BULLETIN 9

PROJECT: Yonkers Community School 35 – Justice Sotomayor

RE: Coordination Drawings – Architectural Floor Plans
Academic Building

Project Name: Yonkers Community School 35 – Justice Sotomayor
 Summary of Adjustments – MEP Coordination – Academic Building

Job No.	2019-1026	Date	08/31/2020
Scale	AS NOTED	Drawn / Checked	-/-
Sheet Number	A202

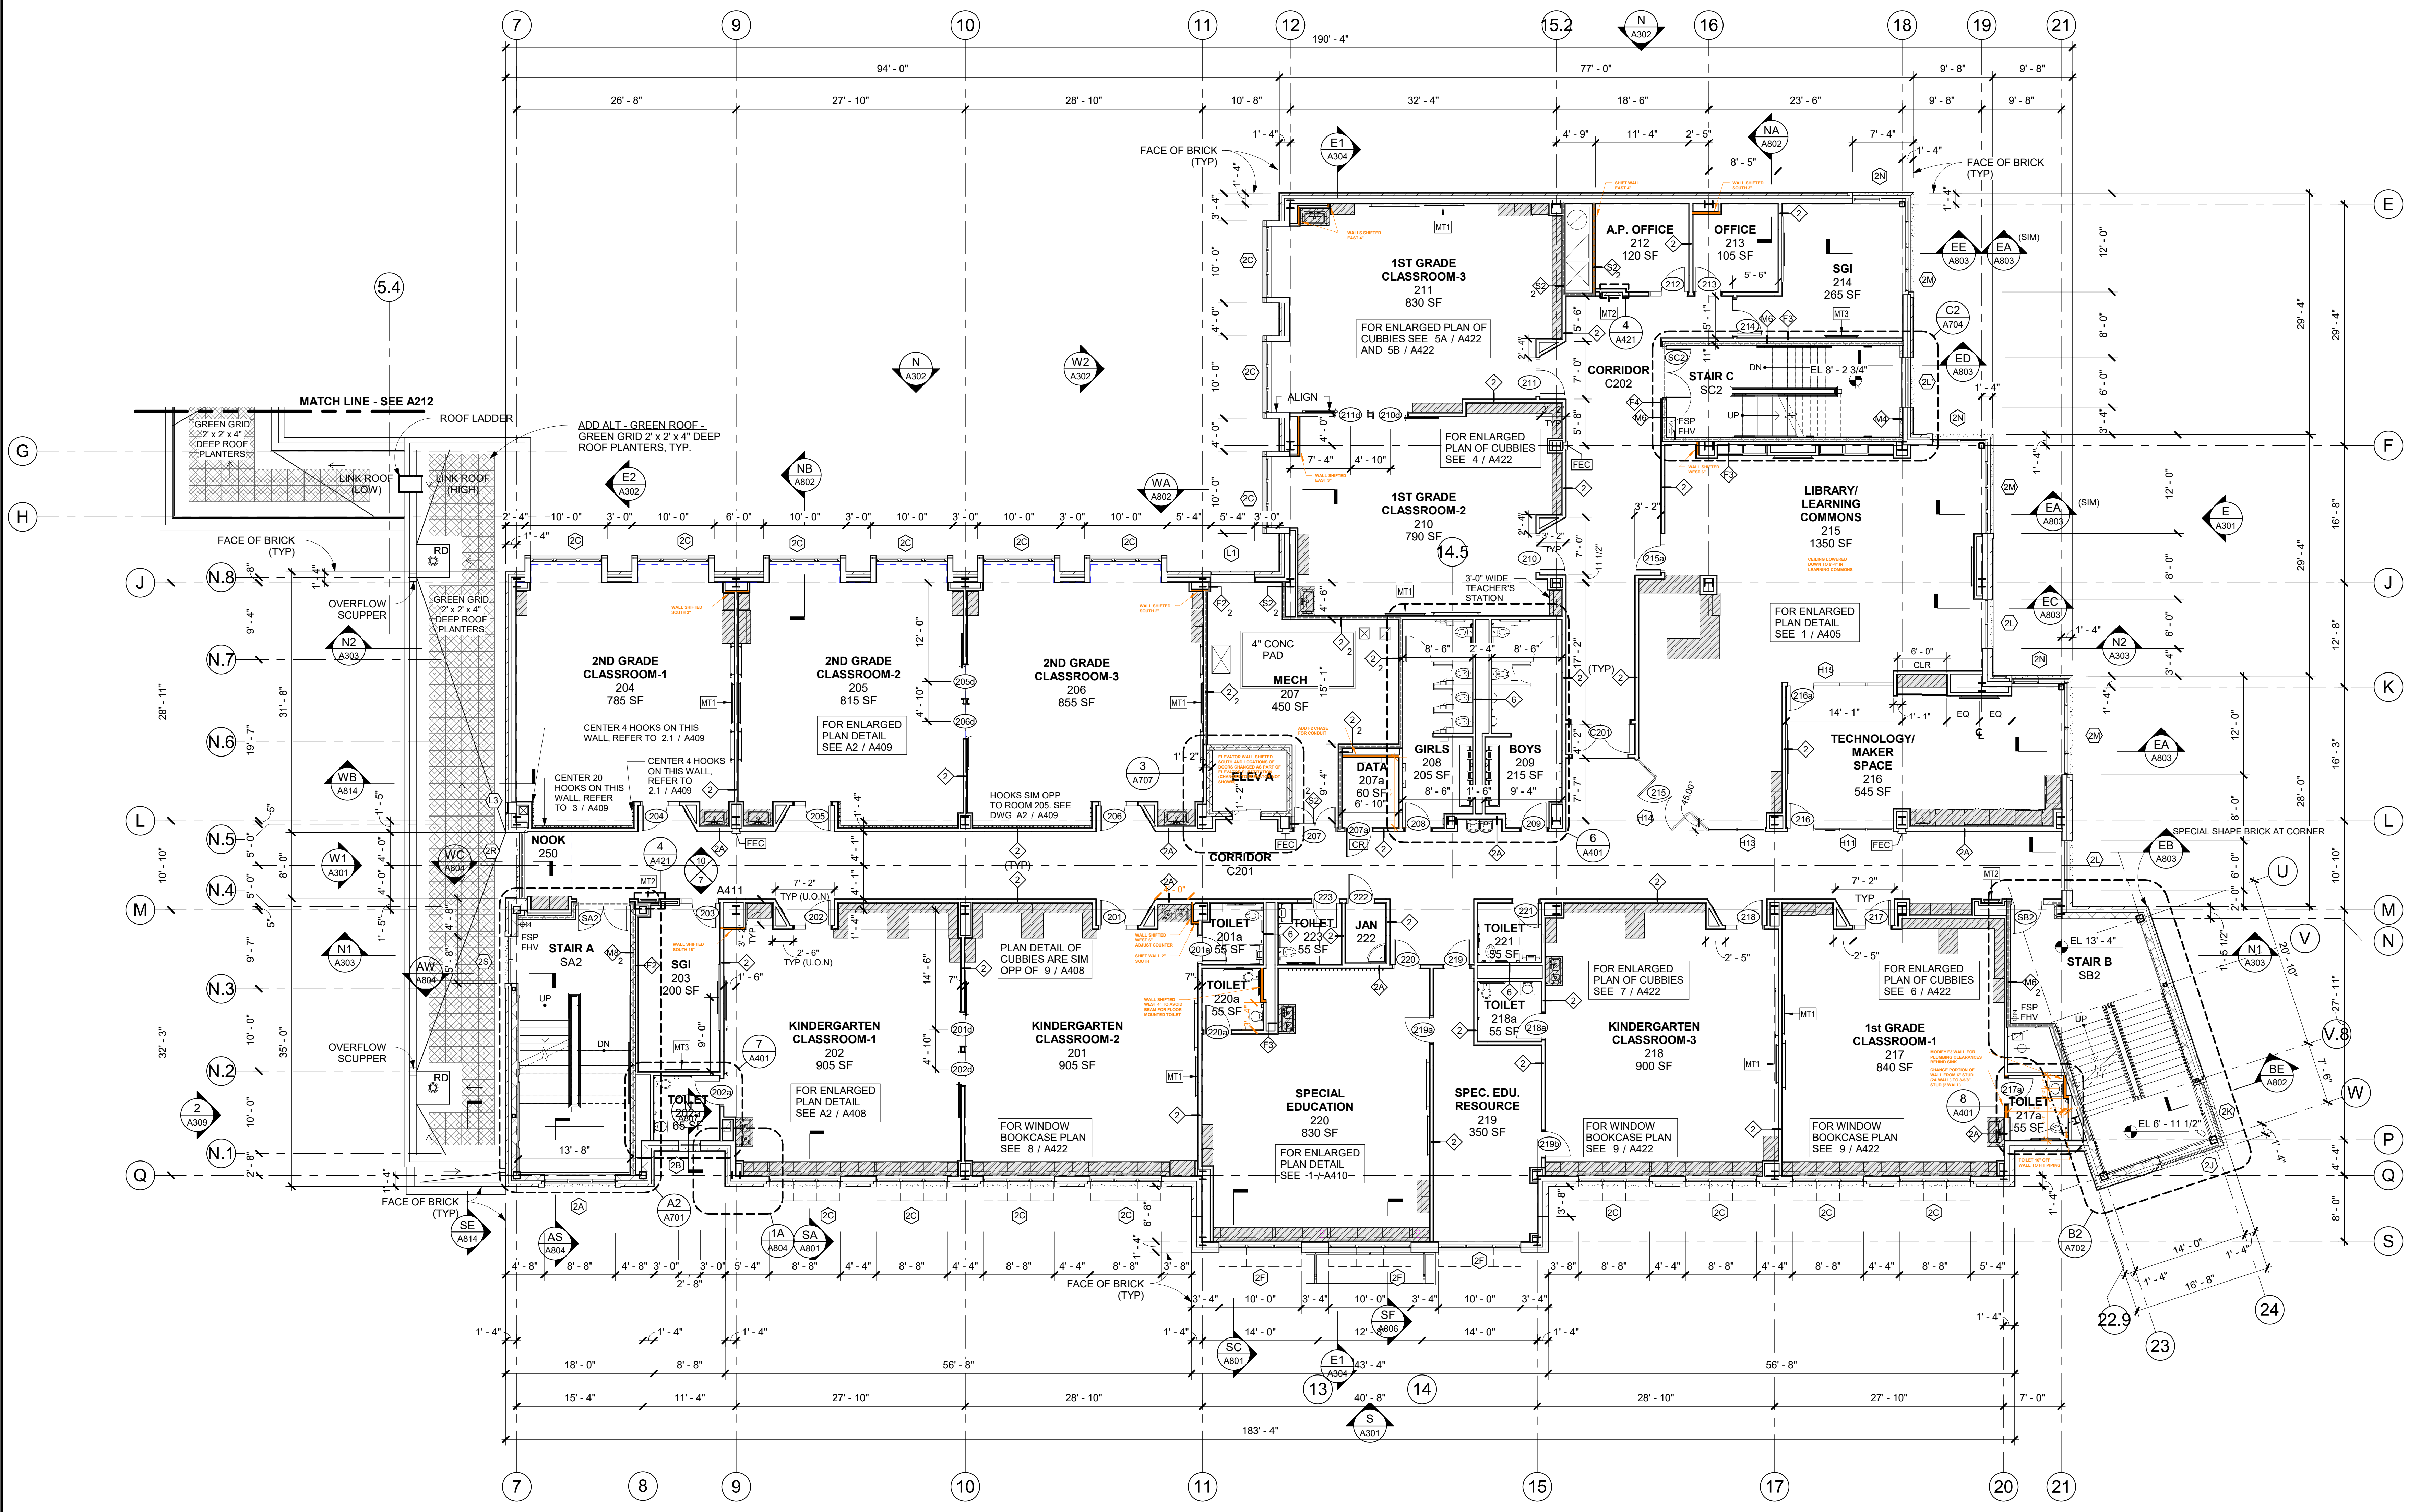
CLASS 201	Shift NE chase wall 6" West and 2" South. Adjust / reduce length of counter accordingly.	See REVISED SHEET A202
CLASS 202	Shift NW chase wall 16" South.	See REVISED SHEET A202
CLASS 204 & 205	North chase wall shifted South 3".	See REVISED SHEET A202
CLASS 206	NW chase wall shifted South 2".	See REVISED SHEET A202
DATA 207a	Add chase wall for conduit.	See REVISED SHEET A202
CLASS 210	Shift Western chase wall 3" East	See REVISED SHEET A202
CLASS 211	Shift chase wall(s) 4" East in NE corner.	See REVISED SHEET A202
OFFICE 212	Shift shaft wall East 4".	See REVISED SHEET A202
OFFICE 213	Shift chase wall 3" South	See REVISED SHEET A202
LIBRARY 215	Shift NW chase wall 6" West	See REVISED SHEET A202
TOILET 217a	Toilet shall be 16" off wall to fit piping between structural steel. Modify chase wall for plumbing behind sink. Change portion of West wall from a 6" stud to 3-5/8" stud.	See REVISED SHEET A202

TOILET 220a	East chase wall shifted West 4" to avoid beam for floor mounted toilet.	See REVISED SHEET A202

LIBRARY 215	Lower ceiling in Library/Learning Commons from 10'-0" to 9'-4"	
-------------	--	--

Sheet Number
A203

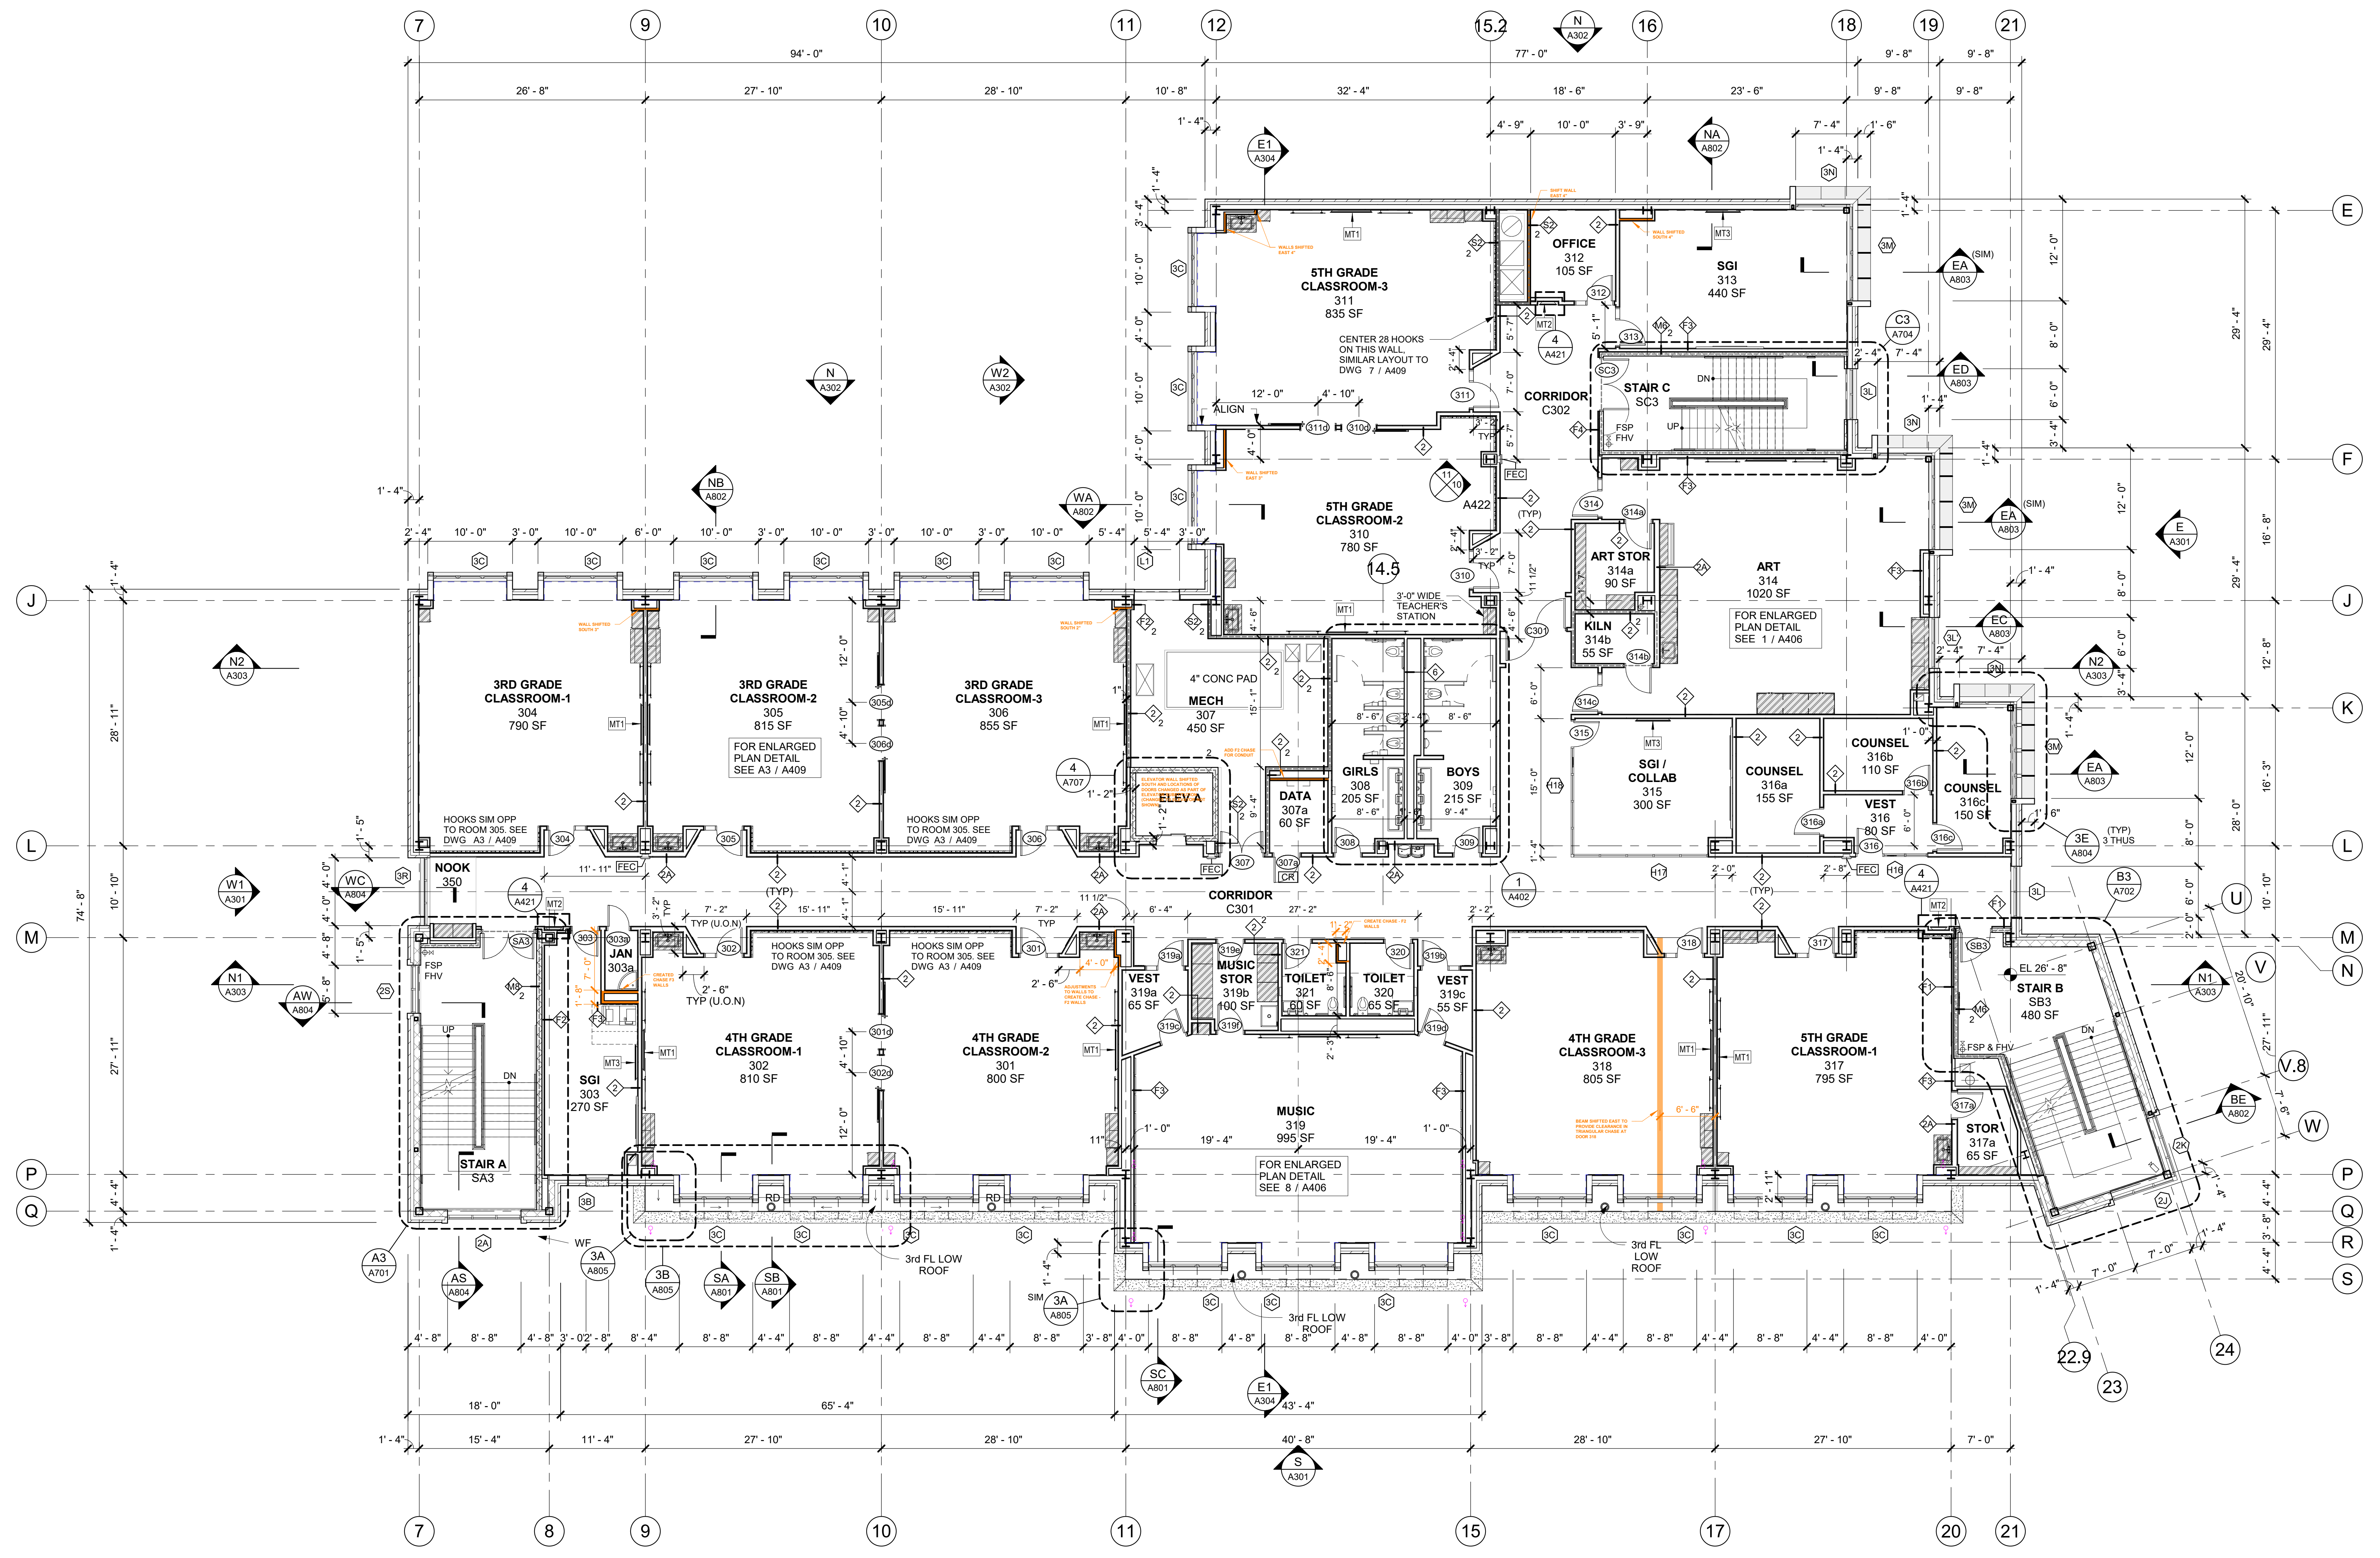
CLASS 301	Adjust NE chase and counter.	See REVISED SHEET A203
JAN 303a	Create F3 chase wall at South end of Janitor Closet	See REVISED SHEET A203
CLASS 304 & 305	North chase wall shifted South 3".	See REVISED SHEET A203
CLASS 306	NW chase wall shifted South 2".	See REVISED SHEET A203
DATA 307a	Add chase wall for conduit.	See REVISED SHEET A203
CLASS 310	Shift Western chase wall 3" East	See REVISED SHEET A203
CLASS 311	Shift chase wall(s) 4" East in NW corner.	See REVISED SHEET A203
OFFICE 312	Shift shaft wall East 4".	See REVISED SHEET A203
SIG 313	Shift chase wall 4" South	See REVISED SHEET A203
TOIL 321	Create F2 chase wall in NE corner of toilet room.	See REVISED SHEET A203

CLASS 318	Beam shift to provide clearance in chase adj. to Door 318. Adjustment to beam was shown on the reviewed shop drawings.	See REVISED SHEET A203
-----------	--	------------------------
